Surry Power Station

Proposed Technical Specification Changes

Attachment 2

Discussion and Significant Hazards Consideration

ALLOWABLE AIR PARTIAL PRESSURE SURRY POWER STATION UNITS 1 AND 2

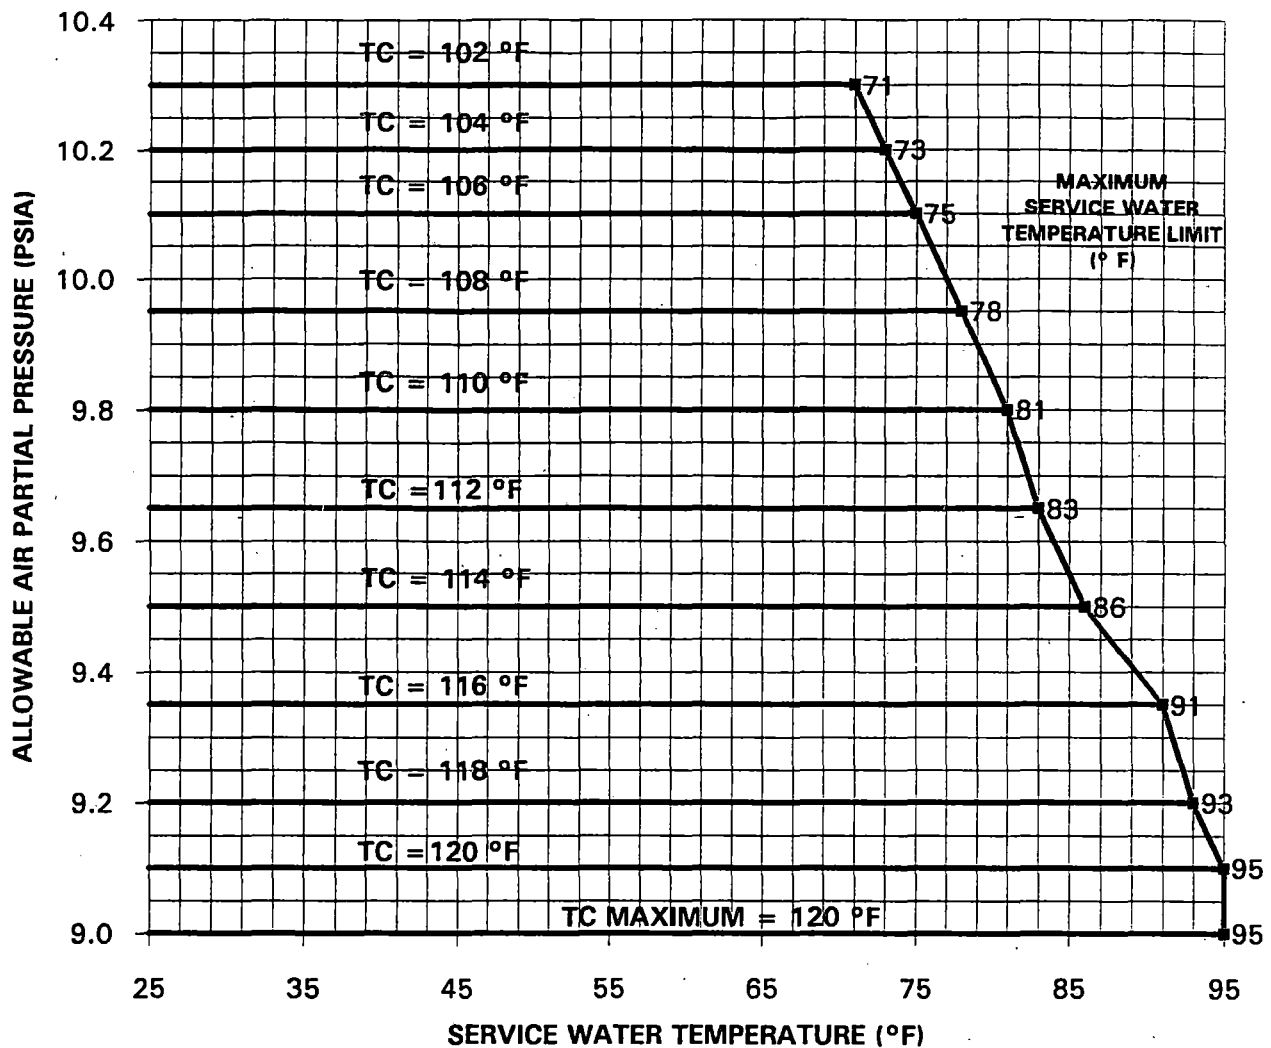
To ensure that the containment will be depressurized and be maintained subatmospheric in the event of a DBA, operating restrictions have been placed on the three variables identified above. In the summer during periods of extended hot weather, minimal rainfall, and low tide the service water temperature approaches the limit of 92°F. With service water temperature at or near its limit, the operating range for containment partial air pressure becomes very restrictive. Therefore, to allow operation at elevated service water temperatures while providing additional operating flexibility for maintaining containment air partial pressure, we are proposing to revise Technical Specification Figure 3.8-1, "Allowable Air Partial Pressure."

The containment response analysis has been reperformed at a three degree higher service water temperature limit for containment air partial pressures of 9.1, 9.2, and 9.35 psia. This analysis used models, methods and input consistent with the current analysis of record. The following table presents the results of the calculation:

<u>Parameter</u>	<u>Worst case value</u>	<u>Limit</u>
Peak pressure	44.94 psia	≤45.0 psia
Depressurization time	2860 sec	≤3600 seconds
Subatmospheric peak pressure	- 0.11 psig	≤ 0.0 psig
ESF pump NPSH	> required	≥ required

Peak pressure and ESF pump NPSH were essentially unchanged from the previous analysis of record. Depresurization time increased by seventy seconds and the subatmospheric peak increased by 0.2 psig.

A revised Technical Specification Figure 3.8-1 is being proposed to permit operation with a three degree increase in the service water temperature limit for containment air partial pressures of 9.1, 9.2, and 9.35 psia. These data points likewise limit containment average temperatures to 120, 118, and 116 °F, respectively. This change will shift the service water temperature with respect to allowable air partial pressure and containment temperature. Service water temperature for these points are shifted as follows:

<u>Old Limit</u>	<u>New Limit</u>
92°F	95°F
90°F	93°F
88°F	91°F

The use of TS Figure 3.8-1 is best explained by example. For example, if service water is 86°F then the TS Figure 3.8-1 limits allowable containment air partial pressure to less than or equal to 9.5 psia. If the containment air partial pressure is 9.5 psia, then containment temperature is limited to less than or equal to 114°F. The use of the figure (how to interpret it) will not be affected by the proposed Technical Specification changes.
